217 WEST 57TH STREET
NEW YORK, NY

VOLUME 2 OF 2 - ZONING

Summary of Comments on P:\Projects\1216-00\BIM\Revit \Families\TITLEBLOCKS\EXTELL Proposal_atwalj.pdf

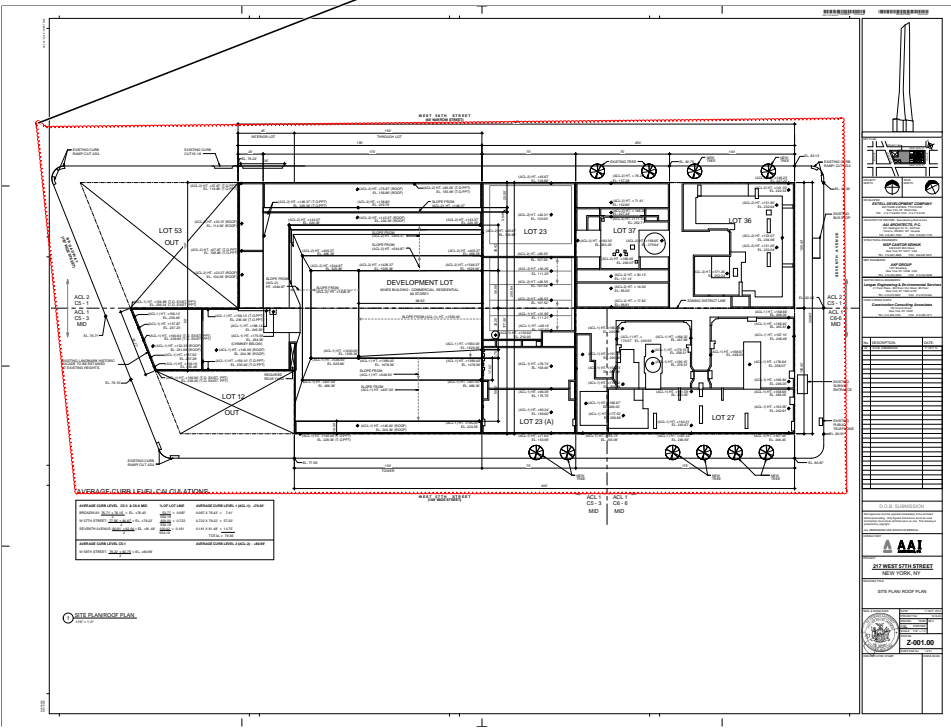
ZRD 1 submitted for ind. AC units within each res. units as a mech. deduction. Verify at next appointment.

Verify compliance with street tree planting for the entire zoning lot street frontage as per ZR 33-03. Provide ST-1

Author: dtitus Subject: Polygon Date: 1/7/2013 9:09:57 AM
Area indicated is for residential use only with a sq. footage of 1,505.
Fifteen square feet is required per bicycle parking space; commissioner approval is required if submission of a more efficient layout is provided.
(Please indicate in Schedule "A" square-footage with total bicycle parking provided)

Author: dtitus Subject: Polygon Date: 1/4/2013 10:59:34 AM
Provide application for low income housing. 104166466 11-13-13

Provide HPD letter. Indicate compliance with inclusionary floor area calculations on zoning floor area schedule to identify compliance with HPD inclusionary housing letter.

Provide records to verify proof of existing conditions shown on plans provided, approved drawings of existing building floor area zoning calculation to ensure that the proposed zoning analysis does not exceed the maximum permitted

Verification of existing mechanical deductions is required. Sufficient proof must be provided for entire the deducted floor area. (Dimensions) and provide layout of heavy equipment for each floor in consideration to qualify for deductions.

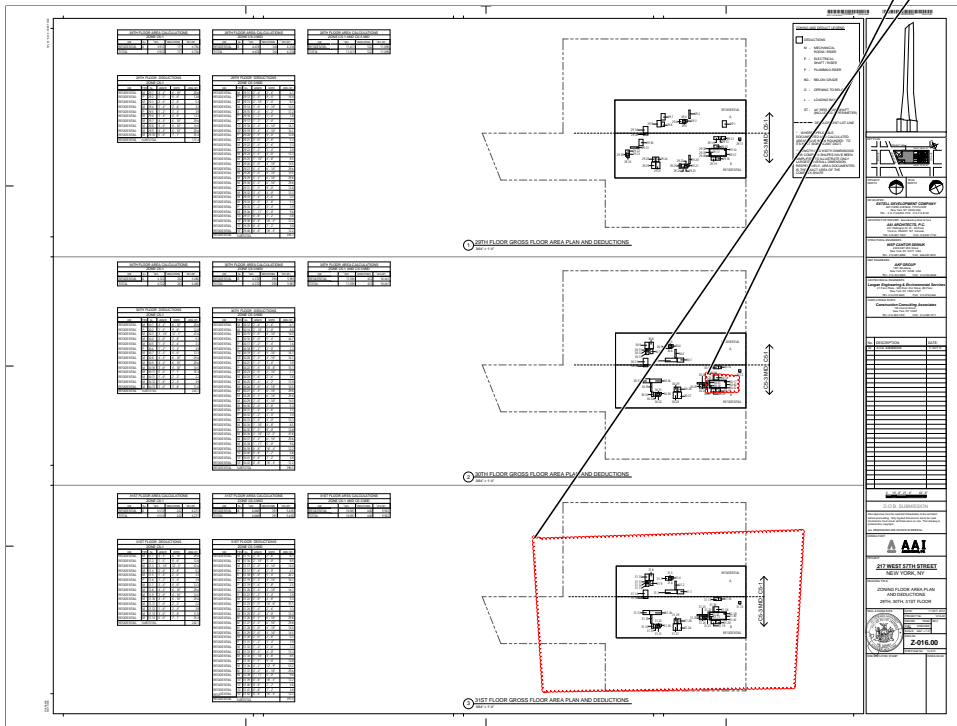
Please clarify deductions taken within stair inclosure. **TYP all floors**
8" for the stair perimeter, not sure what the additional 60+ sq. ft. is for per floor. ARCH/MH dwgs does not indicate any shaft enclosures within stair.

Mech. plan was not provided for this floor. 31st FL.

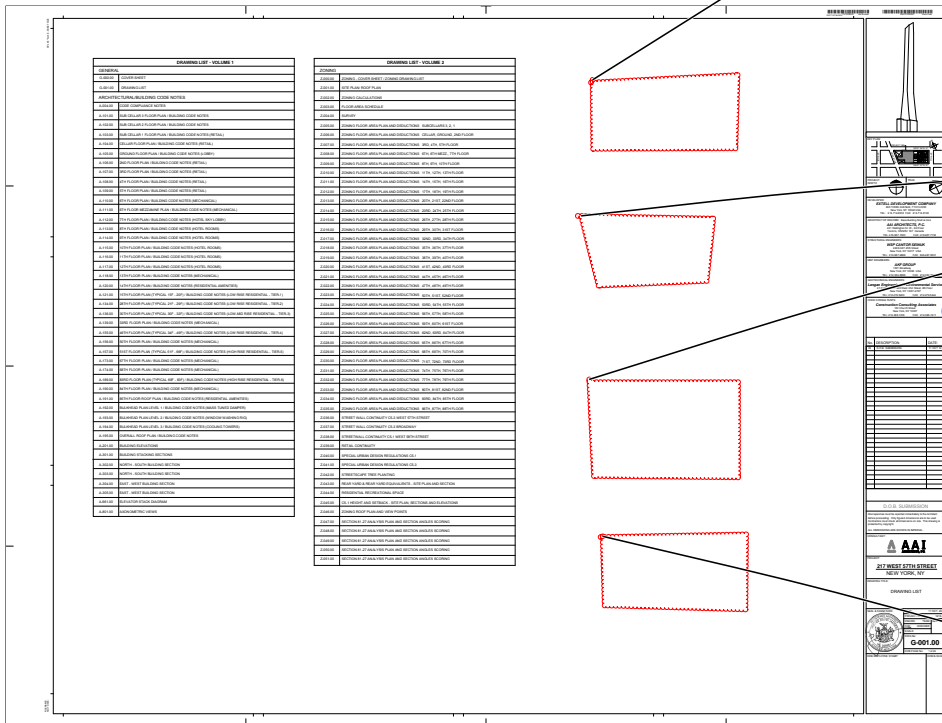
NYC ENERGY CODE 2011
BC 1301 Provide data sheet and state on plans, full compliance with NYC energy code.

List all progress inspections for energy code compliance on drawing.

Supporting documentation: building wall sections fail to detail insulation as continuous and/or cavity insulation to match the location and R value in the energy analysis.

Supporting documentation: door, window and skylight schedules fail to provide columns for u values for each exterior door, window and skylight type. If door, window and skylight types are drawn instead, with specifications included next to the respective drawing, u and SHGC values must appear with the other performance specifications for clarity and ease of contractor take-offs.

Supporting documentation: heating and cooling systems, including controls, are not provided such that they match the systems, equipment and performance criteria in the energy analysis.

Supporting documentation: plans fail to include reflected ceiling plans or lighting layouts on floor plans with fixture types and quantities, lamp wattages and quantities, space areas, sensors and controls to match those in the energy analysis for each room in the building.

Supporting Documentation: Building wall sections fail to label insulation at the roof/ceiling, wall and/or at the foundation, slab-on grade, basement or cellar with R values matching those in the Energy Analysis.

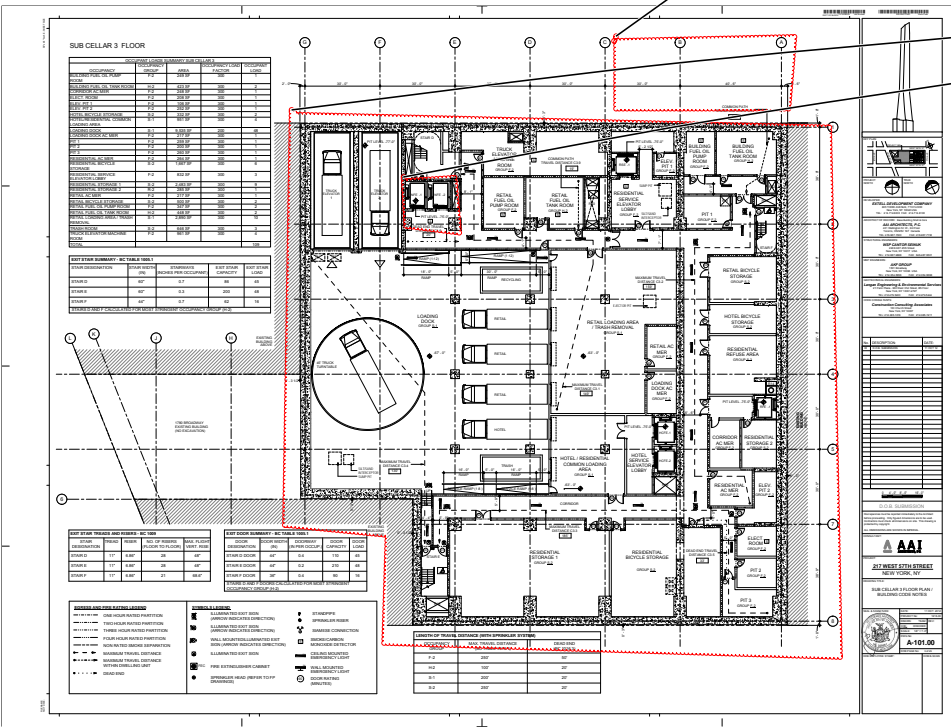
Indicate on drawings fire ratings for all proposed partitions /interior sections and details for verification purposes construction. Indicate construction materials and fire rating of construction elements of building to verify compliance with requirements of Table 601 class I-B structure. 03-09-15

BC 903.2.10 Trash compactor is required for building which contains more than 12 units.

Indicate trash compactor size, dimensions, & location.

- Indicate clearance around trash compactor
- Indicate sprinkler locations in the trash compactor room.
- Indicate ventilation to fresh air at trash compactor room
- provide floor drain at trash compactor room
- Indicate a minimum, 3 hr fire rated enclosure (walls) at trash compactor room i, including 1 1/2hr FRSC-rated door.
- Indicate construction details and materials at trash compactor room
- Indicate sound transmission class (stc) ratings for all trash compactor walls and trash chute walls and disposal; room walls.

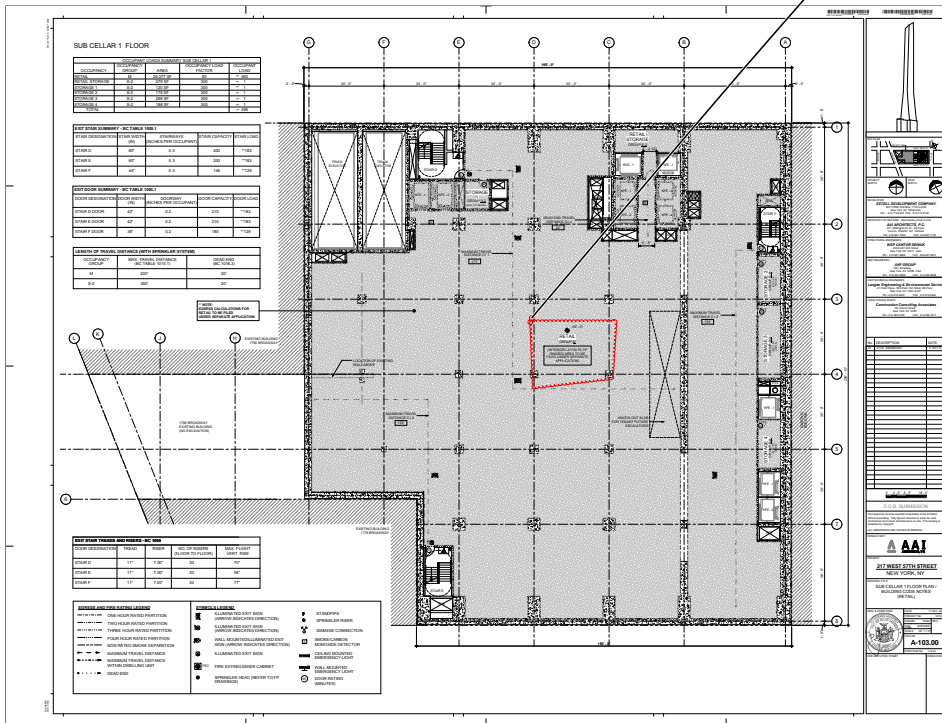
Author: dttus Subject: Polygon Date: 1/7/2013 10:15:09 AM
TABLE 403.1 Provide table for plumbing fixtures to comply with table 403.1. Provide calculations within each space, etc. and show layout to verify compliance to BC 1101.2; ICC/ANSI A117.1-2003

All nonresidential facilities to comply with BC 1109.

Show all grab-bars including vertical

Required clearance around the water closet to comply with ICC/ANSI 2003 604.3

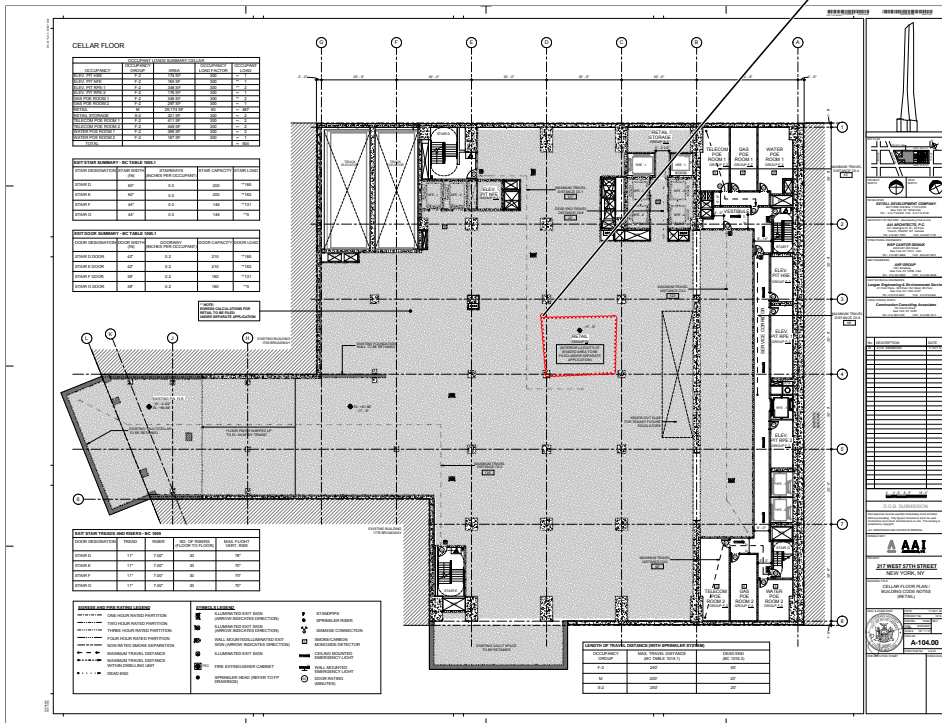
TABLE 403.1 Provide table for plumbing fixtures to comply with table. 403.1. Provide calculations within each space, etc. and show layout to verify compliance to BC 1101.2; ICC/ANSI A117.1-2003

All nonresidential facilities to comply with BC 1109.

Show all grab-bars including vertical

Required clearance around the water closet ~~to~~ comply with ICC/ANSI 2003 604.3

Location of proposed curb cut is contrary to section BC 406.7.6 (3). This is not a corner lot and a minimum separation of 8'-0" is required from side lot line.

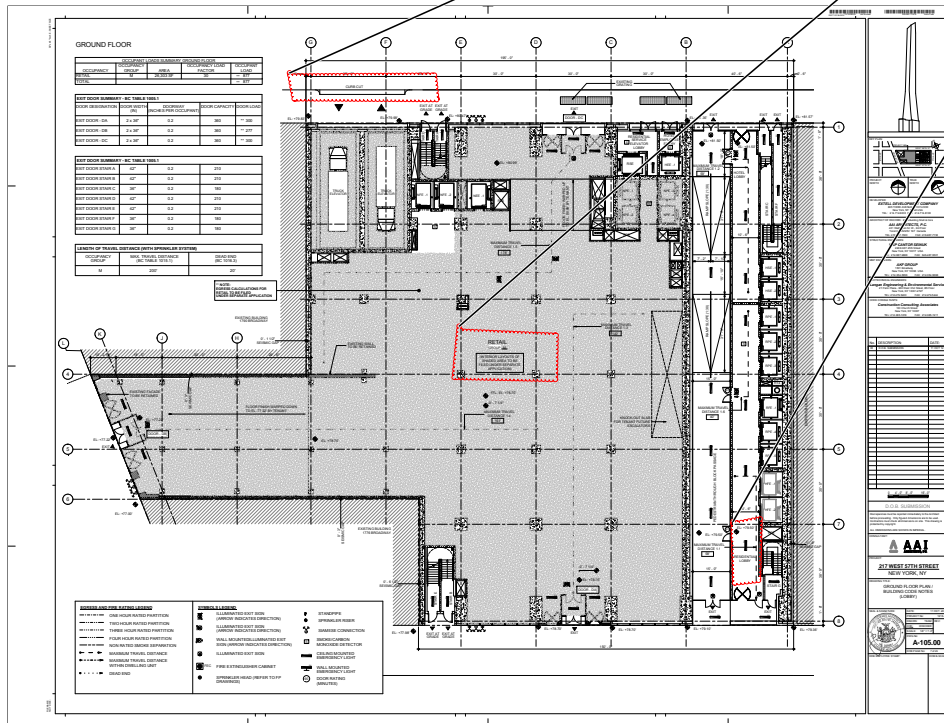
TABLE 403.1 Provide table for plumbing fixtures to comply with table 403.1. Provide calculations within each space, etc. and show layout to verify compliance to BC 1101.2; ICC/ANSI A117.1-2003

All nonresidential facilities to comply with BC 1109.

Show all grab-bars including vertical

Required clearance around the water closet to comply with ICC/ANSI 2003 604.3

Provide note to verify compliance with BC 1008.4.1, 1008.4.2; 1008.4.3; 1008.4.4

BC 1910, LL 17/95 **Earthquake**
state on plan and show compliance with LL 17/95;
separation (1" per 50 ft. height); (compliance must be verified on ~~RA~~ & ST floor plans)
earthquake code applicability & pounding notes;

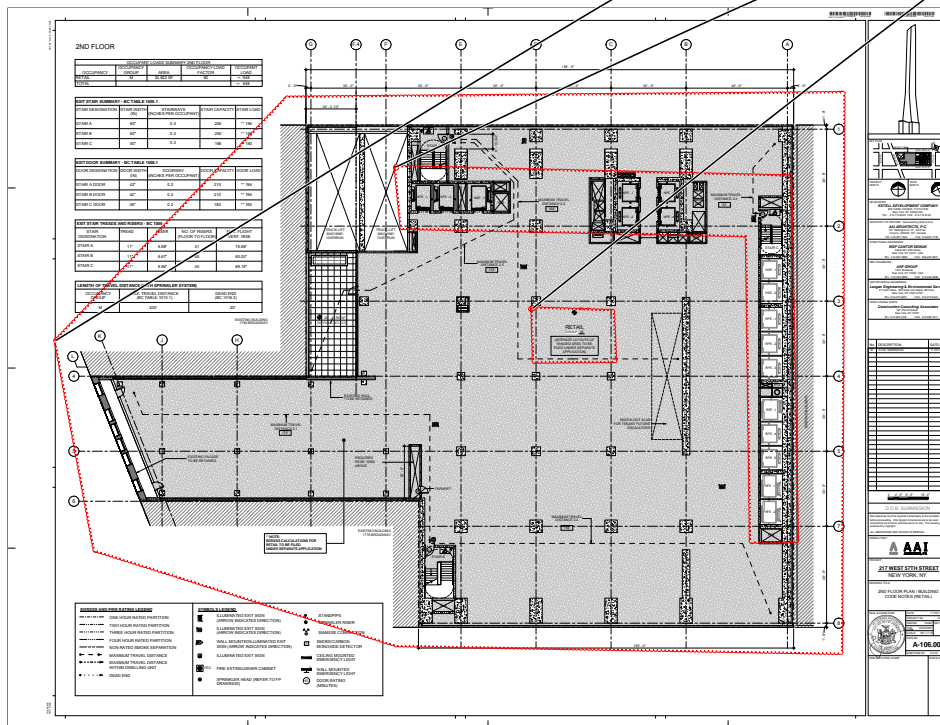
Author: dtitus Subject: Polygon Date: 1/7/2013 9:28:30 AM
Elevator to accommodate 24"x76" ambulance stretcher (BC 3002.4).

TABLE 403.1 Provide table for plumbing fixtures to comply with table. 403.1. Provide calculations within each space, etc. and show layout to verify compliance to BC 1101.2; ICC/ANSI A117.1-2003

All nonresidential facilities to comply with BC 1109.
Water closets

Lavatories
 Show all grab-bars including vertical

Required clearance around the water closet to comply with ICC/ANSI 2003 604.3

Provide exit lighting and directional signs (lighting) & (egress) as per BC 1006, BC 1011, BC 1026 (both EG and Construction plans)

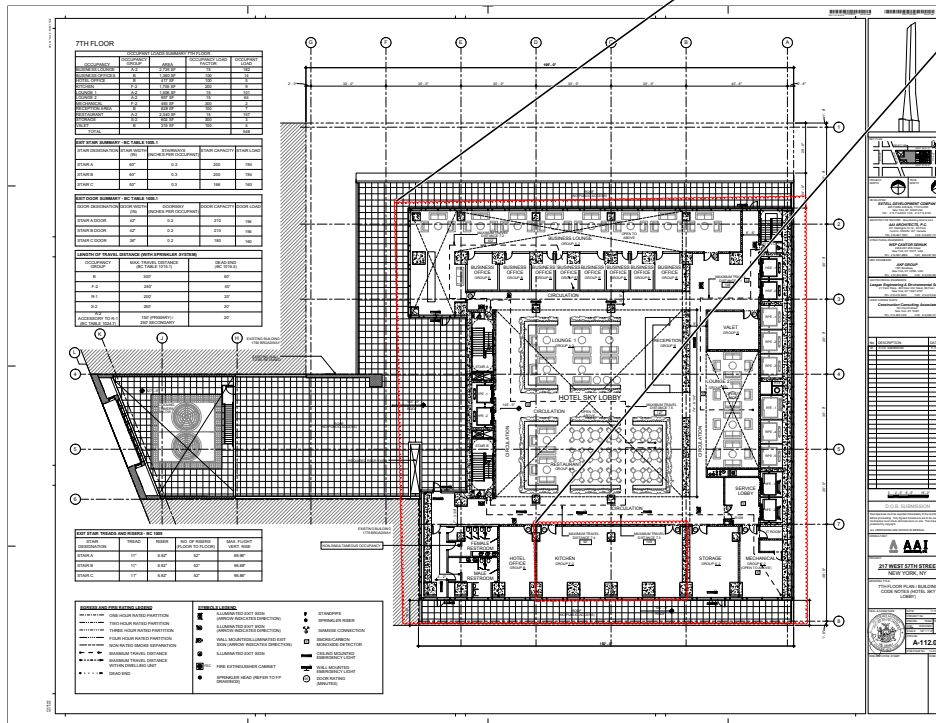
TABLE 403.1 Provide table for plumbing fixtures to comply with table. 403.1. Provide calculations within each space, etc. and show layout to verify compliance to BC 1101.2; ICC/ANSI A117.1-2003

All nonresidential facilities to comply with BC 1109.

Show all grab-bars including vertical

Required clearance around the water closet to comply with ICC/ANSI 2003 604.3

Provide exit lighting and directional signs (lighting) & (egress) as per BC 1006, BC 1011, BC 1026 (both EG and Construction plans)

BC 903.2.12.2 Commercial cooking operations. An automatic sprinkler system shall not be installed in a commercial kitchen exhaust hood and duct system. Fire extinguishing systems shall be installed in commercial cooking systems in accordance with Section 904.11.

BC 904.2.1 Hood system suppression. Each required commercial kitchen exhaust hood and duct system required by the *New York City Fire Code* or the *New York City Mechanical Code* to have a Type I hood shall be protected with an approved automatic fire-extinguishing system installed in accordance with this code.

Kitchen shall also comply with MC 506, 507, and 508; PC 802.1.7 and 1003.3.1. Please verify on MH/PL plans.

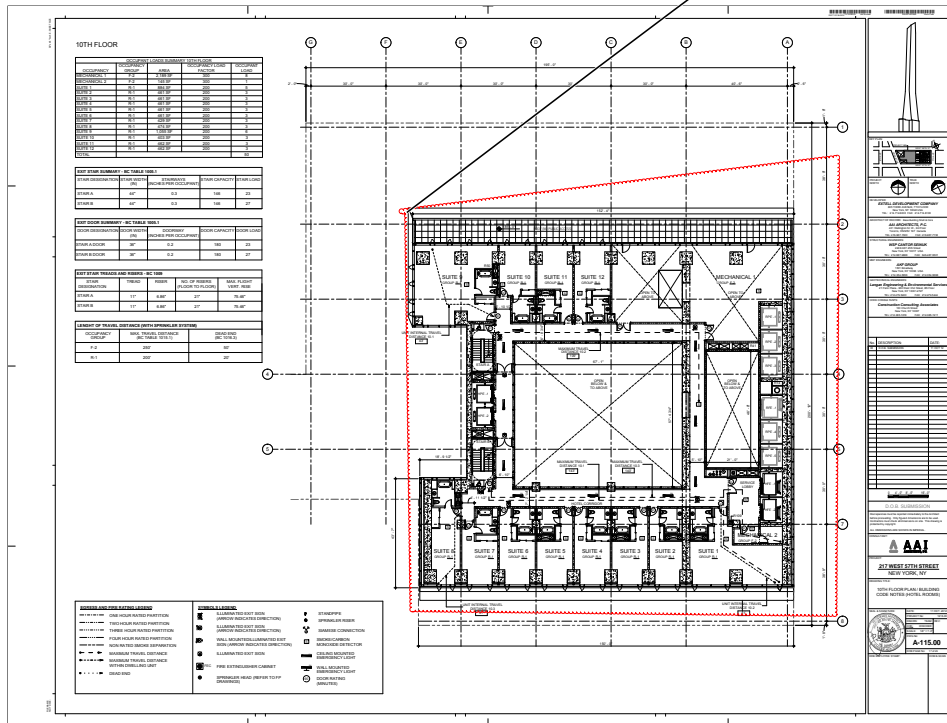
- Provide note describing stairway door operation and stairway communications system as per BC 403.12 04-16-13
- Provide note describing smoke proof exit enclosures for compliance with BC 403.13. 04-16-13
- Provide note describing impact-resistant stairs enclosures as per BC 403.15 04-16-13
- Indicate photo luminescent exit path markings as per BC 403.16. 04-16-13
- Provide exit lighting and directional signs (lighting) & (egress) as per BC 1006, BC 1011, BC 1026 (both EG and Construction plans) 04-16-13

- Group R-1 occupancies shall be provided with accessible features in accordance with Sections 1107.6.1.1 through 1107.6.1.3.
- Show all grab-bars including vertical as per P102.8.3.1, (TYP)
- Provide note within each accessible unit or sleeping unit shall comply with the 2008 code and Chapter 1 through Chapter 10 of ICC A117.1. (TYP) 04-16-13

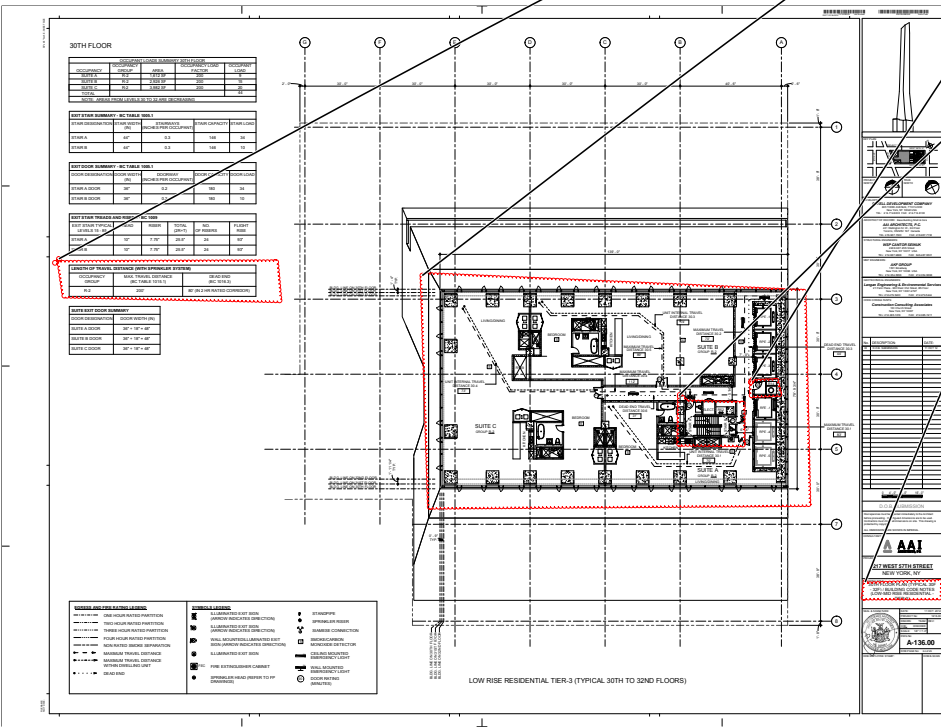
Author: dtitus Subject: Polygon Date: 1/7/2013 9:31:18 AM
The common path of egress travel shall not exceed 125 feet as per BC 1013.3. The maximum length of exit access travel, measured from the most remote point within a story/space to the entrance to an exit along the natural and unobstructed path of egress travel, shall not exceed the distances given in BC Table 1015.1.

Author: dtitus Subject: Polygon Date: 1/7/2013 9:30:14 AM
BC 908.7.1.2 Provide notes to indicate compliance for carbon monoxide detectors.
Indicate location of smoke/ carbon monoxide detectors. (TYP.)

Author: dtitus Subject: Polygon Date: 1/4/2013 10:06:27 AM
Provide refuse chute details: [2 hr fr walls & roof] and compliance with BC 1213.3 and BC 707.13
Refuse storage room to comply with BC 1213.1
Provide proper enclosure and details
Provide UL # for system or fire hopper doors
Compliance with BC 1101.2;

Author: dtitus Subject: Polygon Date: 1/4/2013 10:41:39 AM
Provide note describing stairway door operation and stairway communications system as per BC 403.12
Provide note describing smoke proof exit enclosures for compliance with BC 403.13.
Provide note describing impact-resistant stairs enclosures as per BC 403.15
Provide exit lighting and directional signs (lighting) & (egress) as per BC 1006, BC 1011, BC 1026 (both EG and Construction plans)

Author: dtitus Subject: Polygon Date: 1/4/2013 10:05:14 AM
Please indicate as Typ. 30-32nd Floor Plans

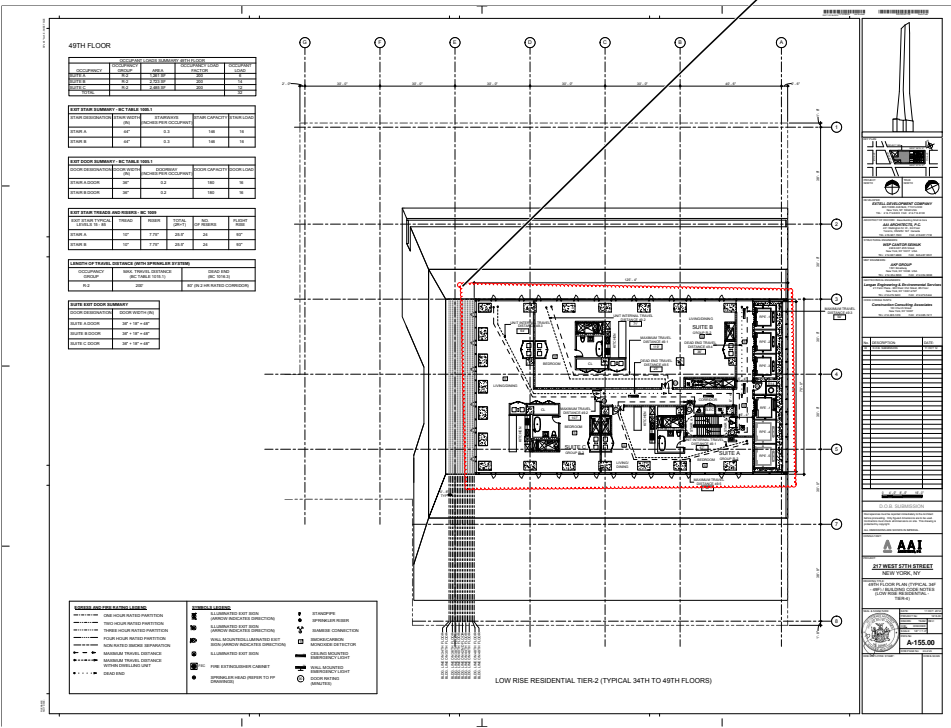
BC 1101.1, 1101.2, and
ICC/ANSI A117.1-2003 Verify compliance with accessibility as per BC 1101
Primary access- 1105
Doors & maneuvering clearances-1107.2.1
Residential bathrooms – 1107/ Appendix P
Residential kitchens – 1107.
Show all grab-bars including vertical as per P102.8.3.1,
Walk-in closets
Access to W/D within units
TYP. all R-2 floors
